Luensmann Offsite Water Main Ext PH1
Solicitation Number: CO-00717
Job No.: 23-1043

ADDENDUM 1
11/16/2023

PLAT NO.	
JOB NO.	12473-09
DATE	MARCH 2023
DESIGNER	CD
CHECKED	MP DRAWN CD
SHEET	C3.14

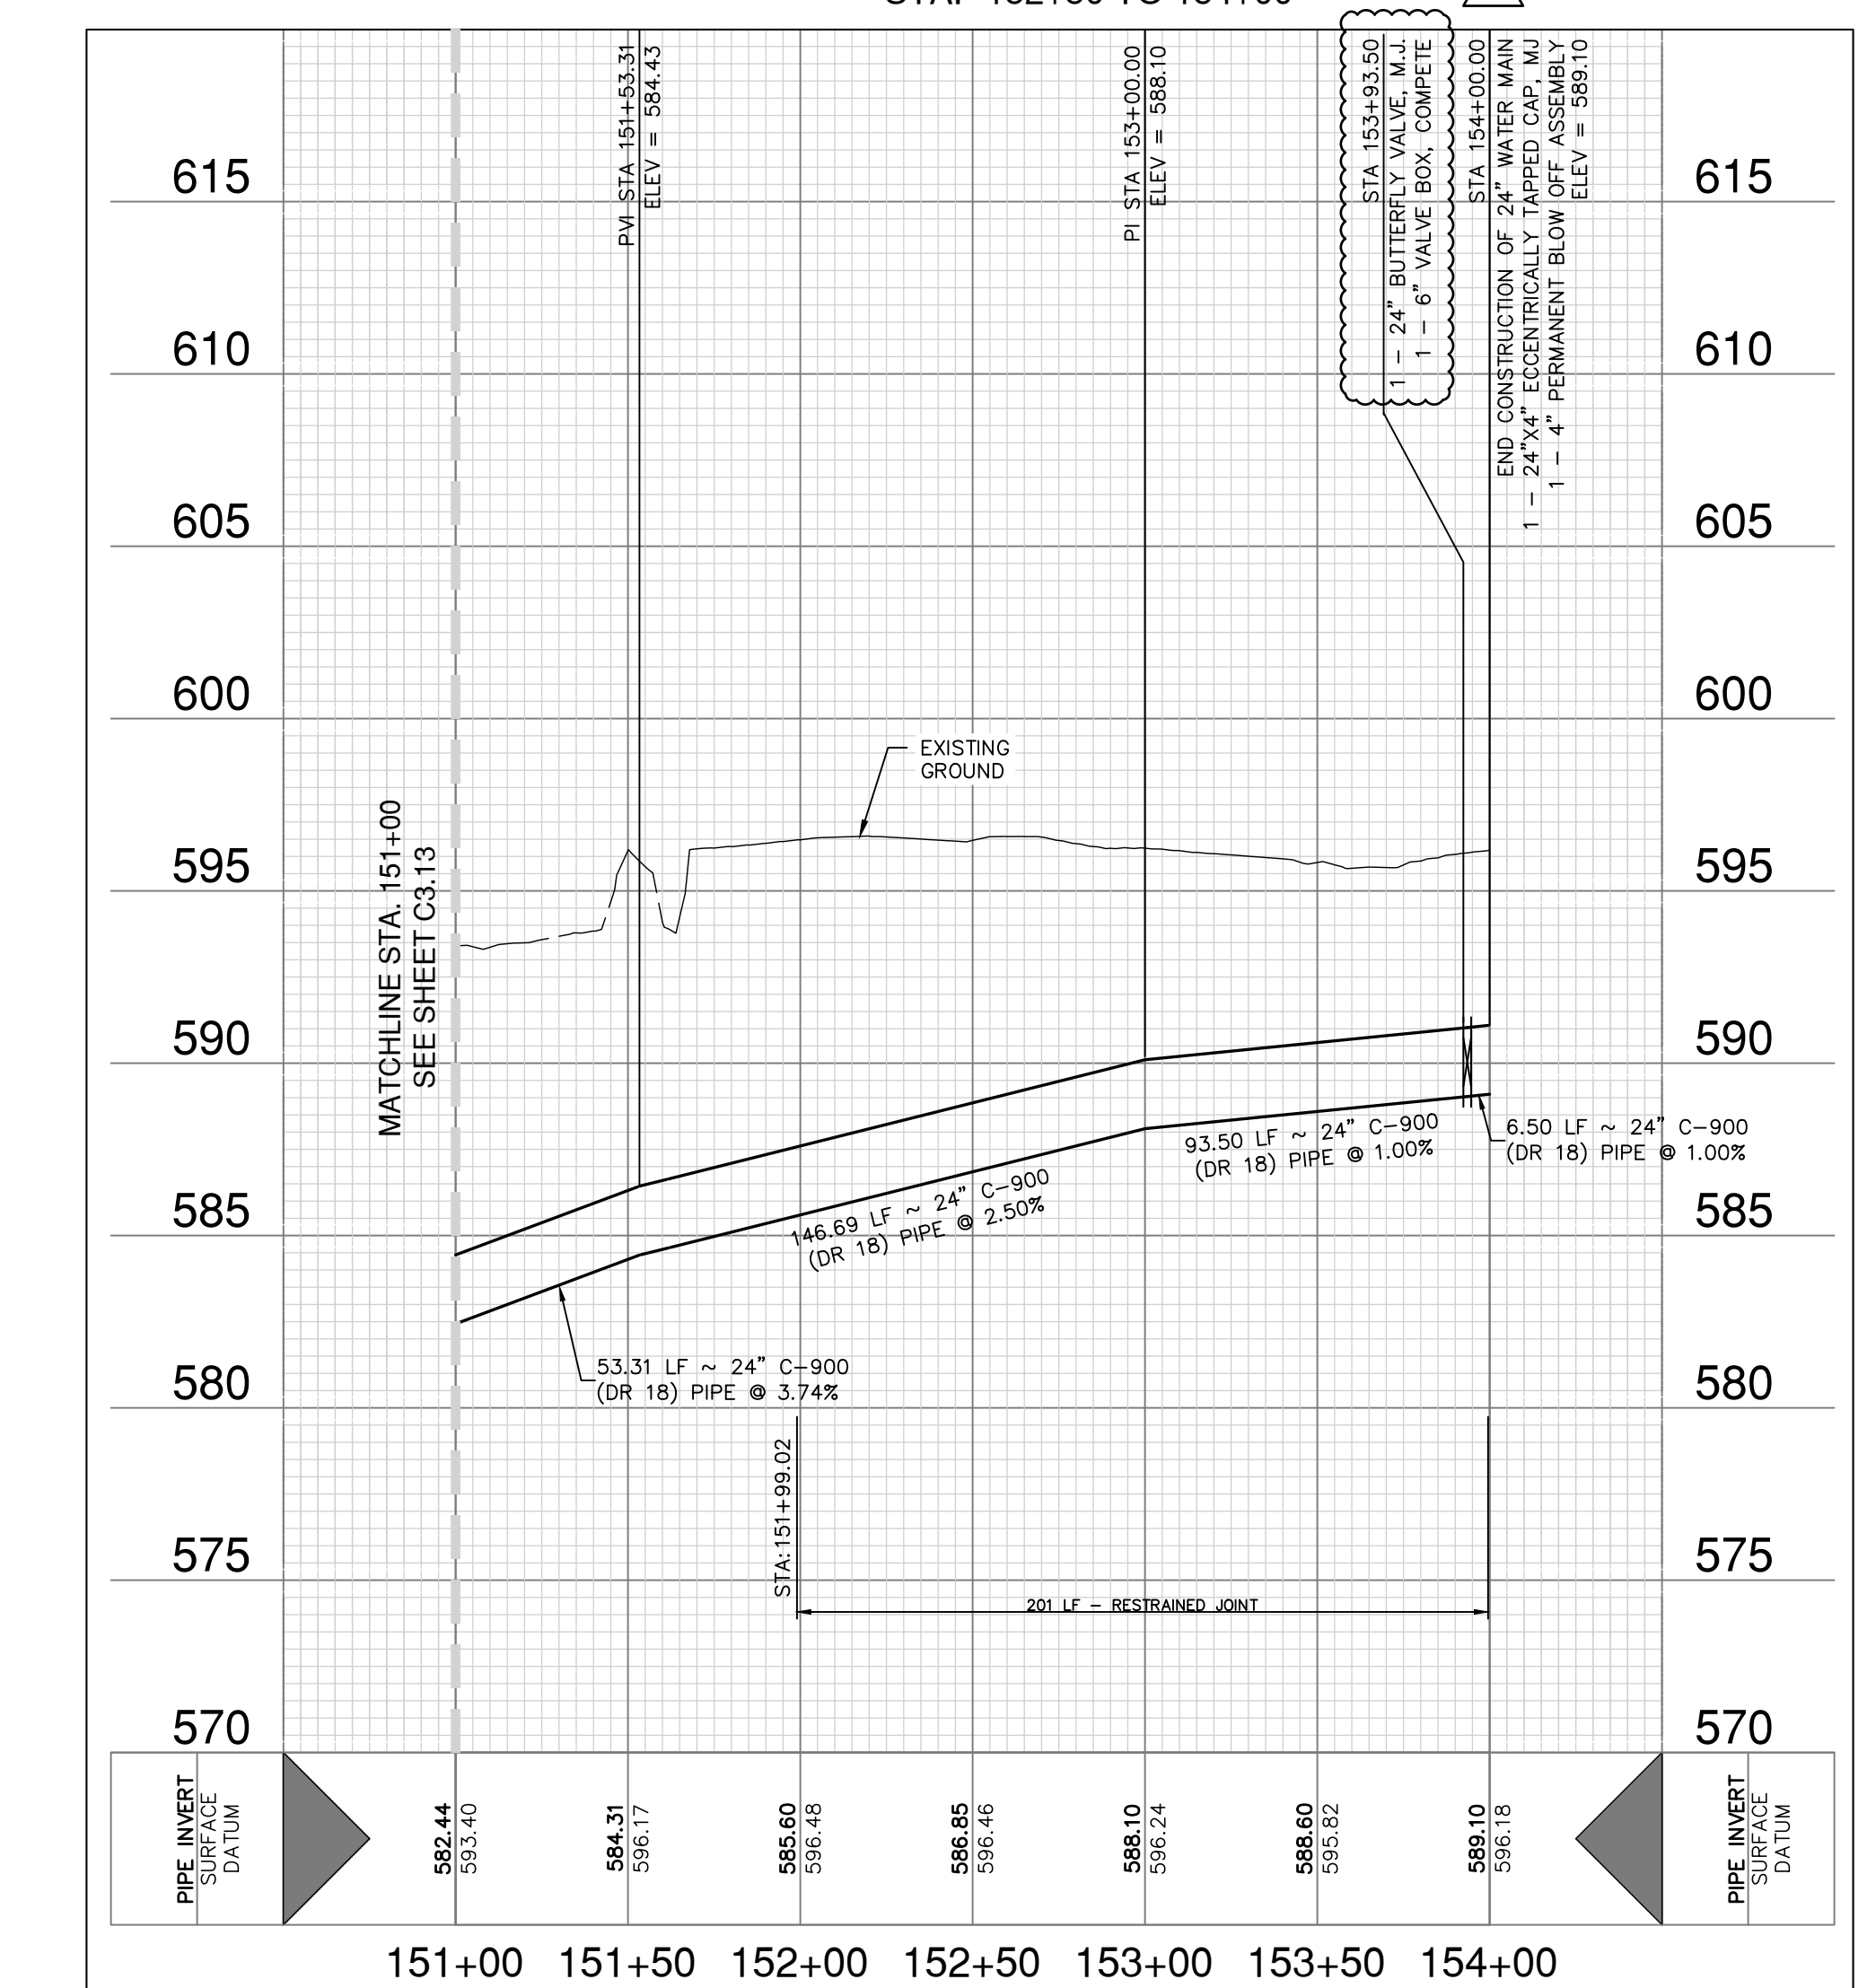
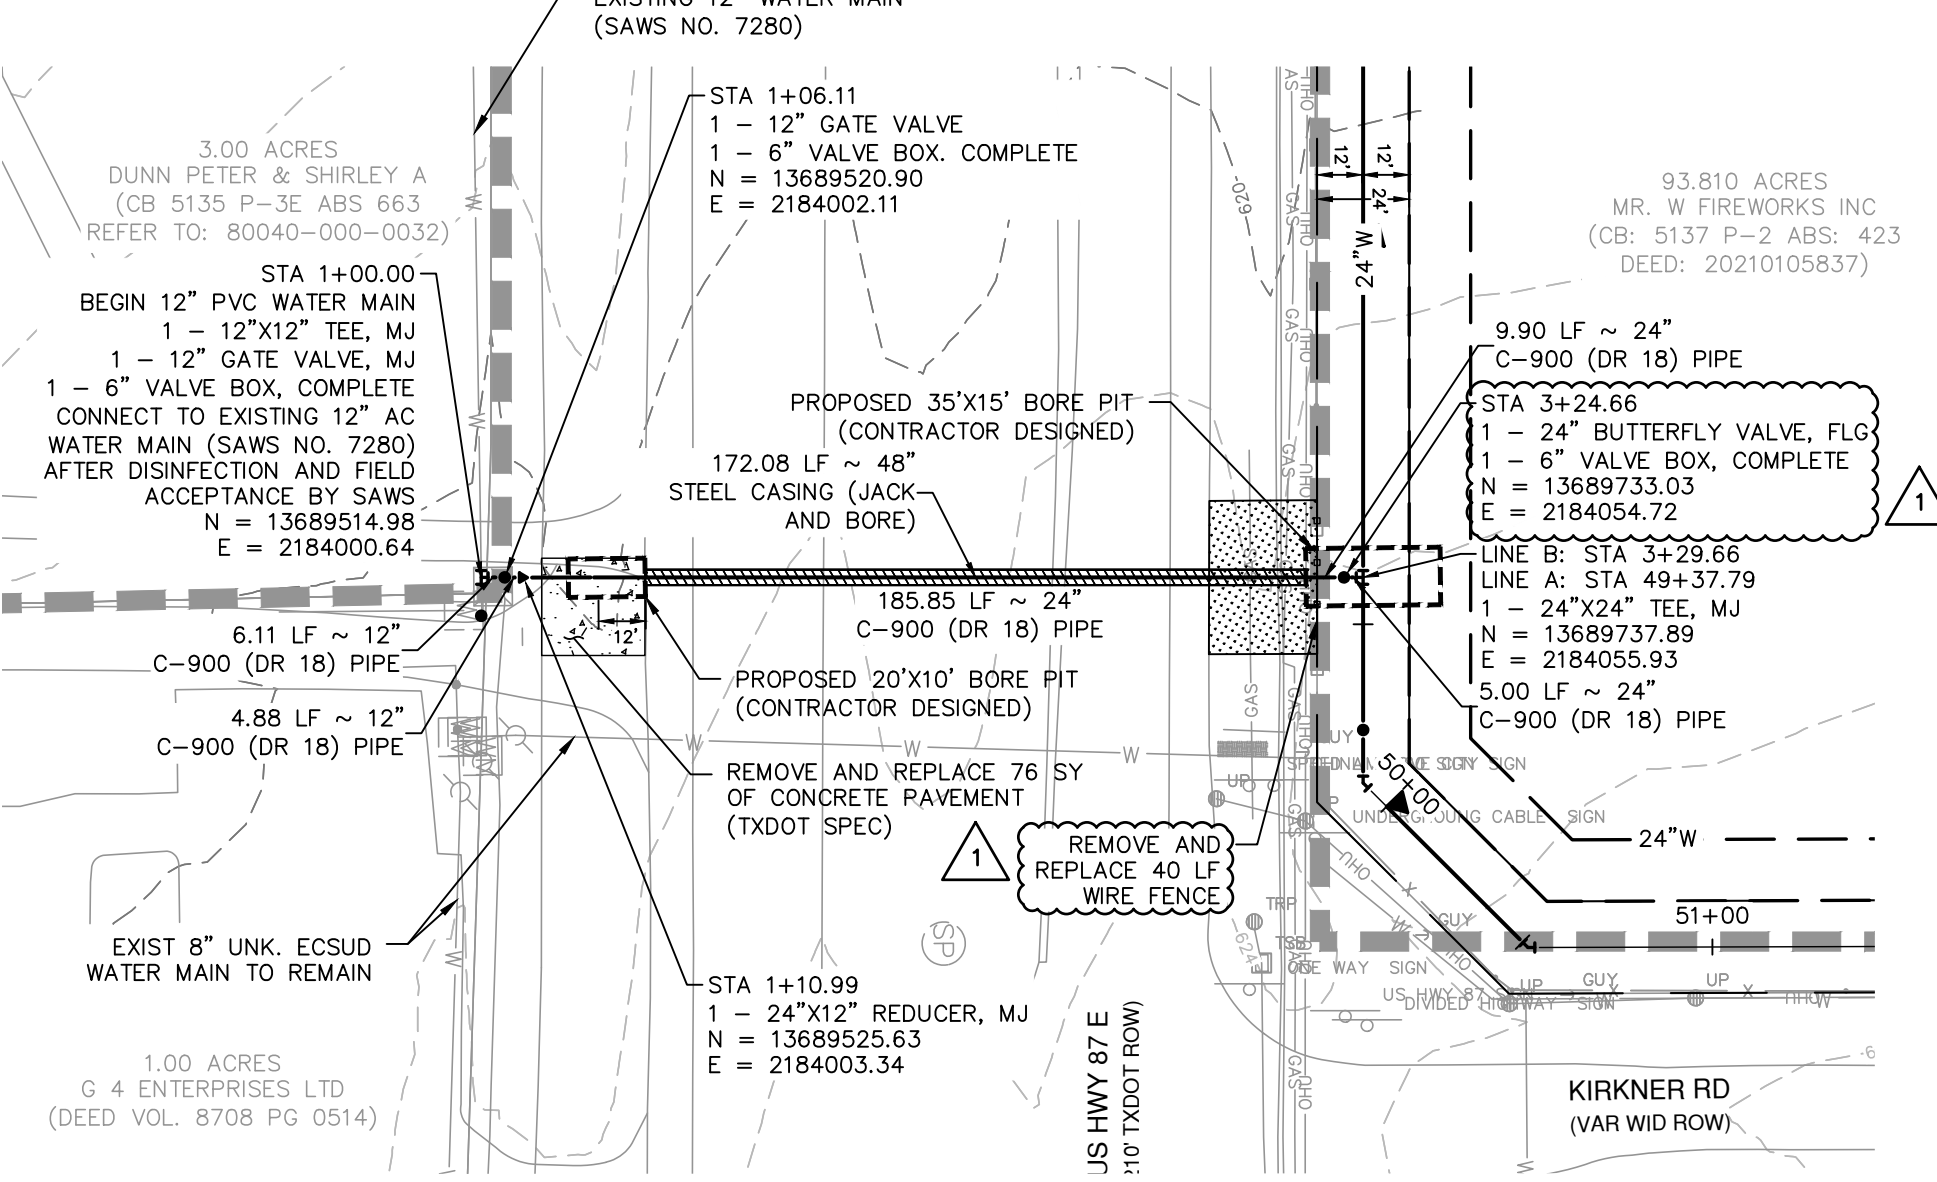
15. **Question:** Bid item 1 – Repair of Concrete Pavement (Full Depth) (TxDOT Spec) has a quantity of 76 CY per the Bid Form. Should that be 76 SY as the quantity on sheet C3.14 shows 76 SY on the quantity table?

- Updated quantity table to add a Fence Gate Type 1 and Remove and Replace Existing Fence
 - Revised 24" Butterfly valve to be Flanged.
17. Sheet C3.14: Water Main Plan and Profile Sta 151+00 to 154+00 – Remove in its entirety and replace with the attached document.
- Updated quantity table to add a Fence Gate Type 1 and Remove and Replace Existing Fence
 - Revised 24" Butterfly valve to be Flanged.

Response: See Changes to the Specifications #1. The quantity for that line item is now "SY."
